CHANGE ORDER
CITY OF VALDEZ

DATE ISSUED December 14, 2017
CHANGE ORDER NO. 06
COST CODE NO. 310-6450-58000
PROJECT NO. 310-6450
CONTRACT NO. 1283

PROJECT: Phase 2 New Harbor Development
Upland Facilities and Inner Harbor Facilities

**REQUEST FOR PROPOSAL
CONSTRUCTION CONTRACT CHANGES**

PROJECT: NEW HARBOR DEVELOPMENT UPLAND FACILITIES
 SHEET NO: 48 OF 103
S4.2

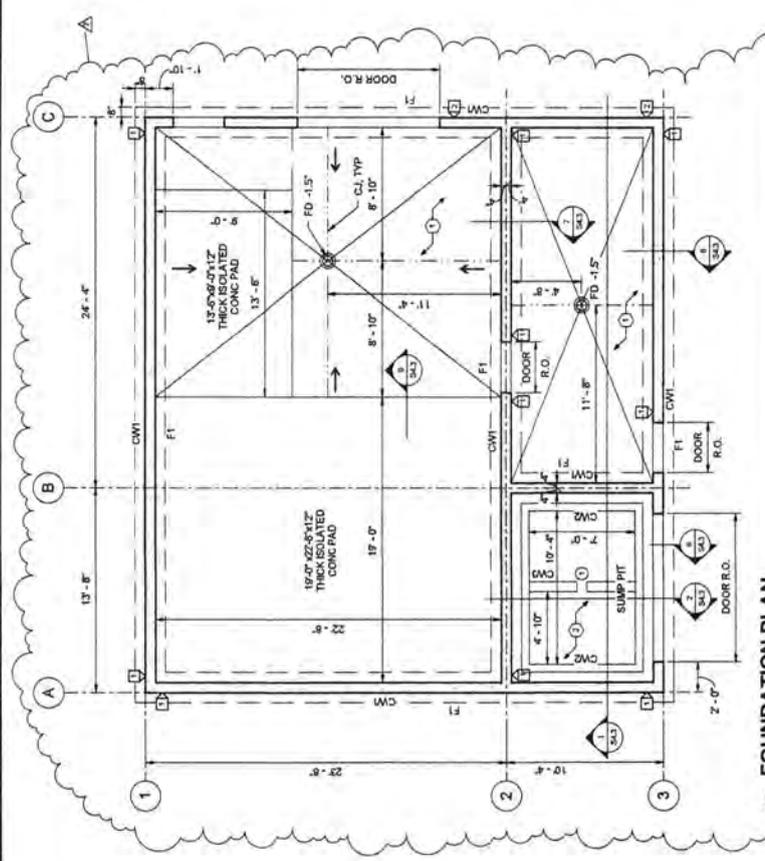
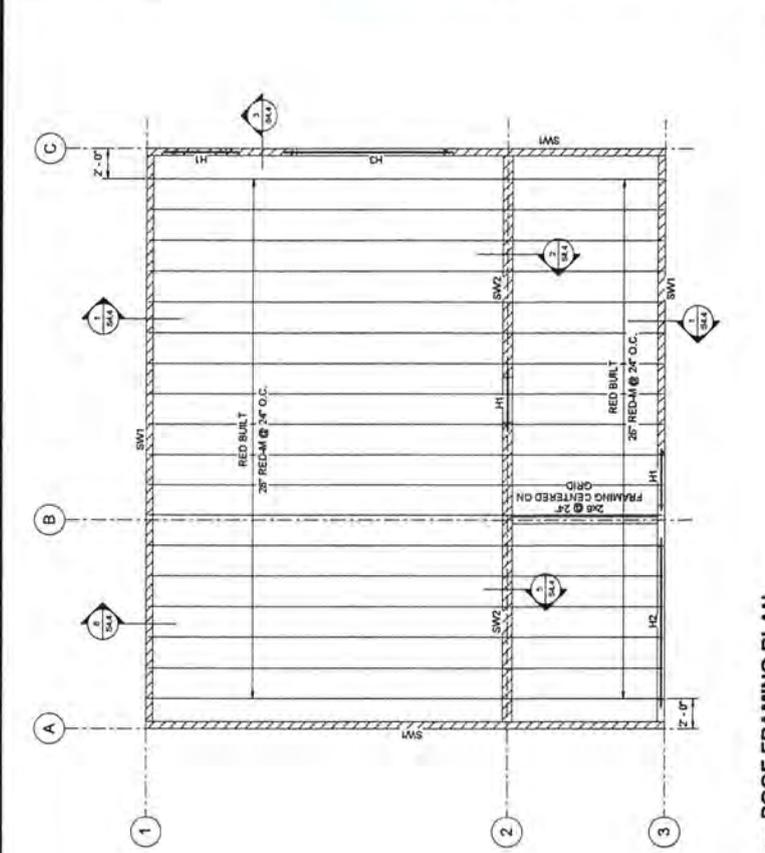
According to the specified and submitted equipment our concrete pad requirements are larger than indicated on S Drawings. The skid for the Oiltrap system is actually 5' longer than the pad, as called out on S4.2 drawing, additionally the Surge Tank pad layout will allow for the tanks to sit on the pad, but does not allow for adequate space to walk between the two tanks if needed. Presently, I calculate roughly the need for 31' 6" of isolated concrete pads across plan view E to W. That would leave us with a total of 6' 6" of additional space for walking around the pads. Split evenly that's about 26" of free space between the pads and that is not what is called out as needed on the S drawings and would conflict with space in front of the RO for doors.

Sheet S4.2 calls for the Elevation of the Isolation Equipment pads in the Bilge Building to be 6" higher than the Building Slab. Because all the Equipment is on Skids we would keep the Isolation Slabs at the same height as the Building Slab.

Minimum edge distance from equipment anchors to edge of thickened concrete pads shall be 12" or as required by the equipment manufacturer's approved anchoring plan (not yet submitted). Equipment anchor details have not been submitted at this time, so the attached drawing (Sheet S4.2 and S4.3) shows a thickened slab plan that can be used to meet current equipment geometry and 12" anchoring edge distance requirements. Attached drawing Sketch SK1 shows the current manufacturer coordinated bilge equipment layout plan.

Isolated slab height lowered per RFI-012.

Agreed. If all equipment is on skids, isolation pads remain isolated, and required thickness is maintained below building slab level, the height may be lowered to equal with building slab level. Coordinate size of isolation pad with planned equipment layout (currently being coordinated as part of RFI011) and anchoring plan (not yet submitted).

86 OF 103
M5.1

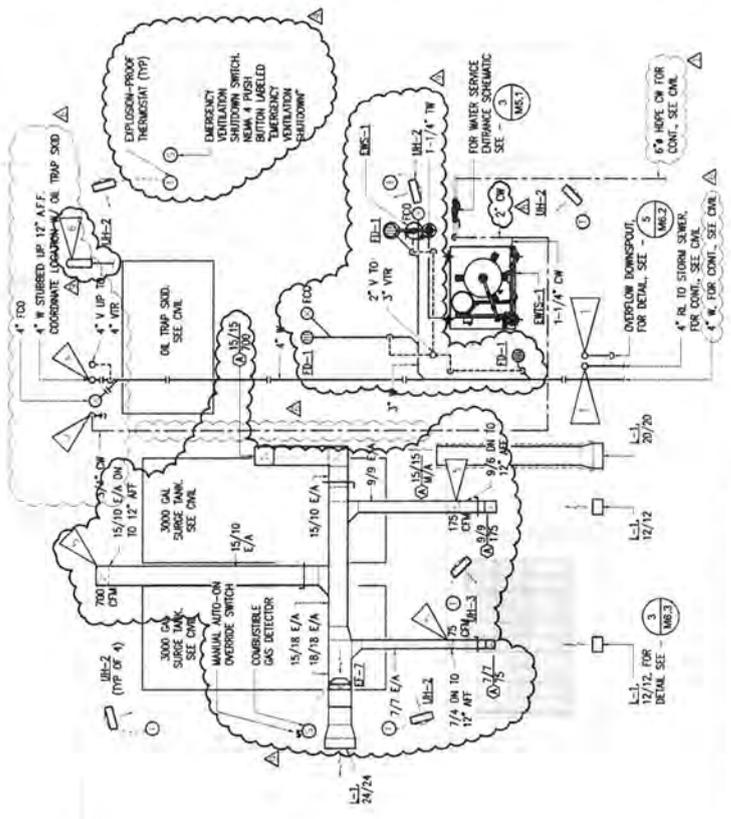
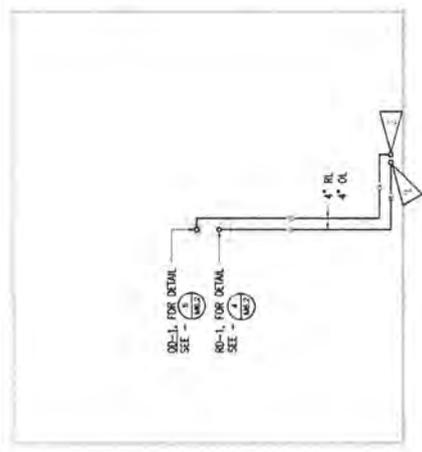
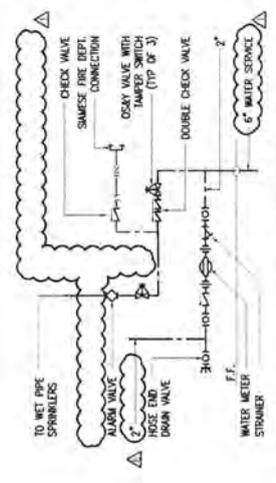
RSA Engineers has provided a modified drawing M5.1 "Bilge Treatment" that incorporates the mechanical changes.

NOTE: BILGE HOUSE IS A CLASSIFIED SPACE. PROVIDE EXPLOSION PROOF/SPARK RESISTANT EQUIPMENT AND MATERIALS AS REQUIRED. REFER TO ELECTRICAL/ARCHITECTURAL FOR CLASSIFICATION

- 1 FOR CONTRIBUTION, SEE - M5.1
- 2 FOR CONTRIBUTION, SEE - M5.2
- 3 PROVIDE 1/4" HOSE BEEB 18" AFF. PROVIDE ANTI-SIPHON, SPILL RESISTANT WAGON BRACKET AT PIPE DROP.
- 4 PROVIDE 2" CAPPED SAMPLING/DRAWER POINT ON HORIZONTAL WASTE DISCHARGE FROM OIL TRAP. PROVIDE CAPPED BALL VALVE. COORDINATE W/ OIL TRAP.
- 5 PROVIDE THROUGH WALL VENT FOR OIL TRAP TANKS. PROVIDE A 4" THROUGH WALL VENT FOR OIL TRAP TANKS. PROVIDE A 4" THROUGH WALL VENT WITH TURNED DOWN ELBOW AND 1/2" SCREEN. PROVIDE 1/2" SCREEN ON E/A OPENING. PROVIDE BLANKING DAMPER.
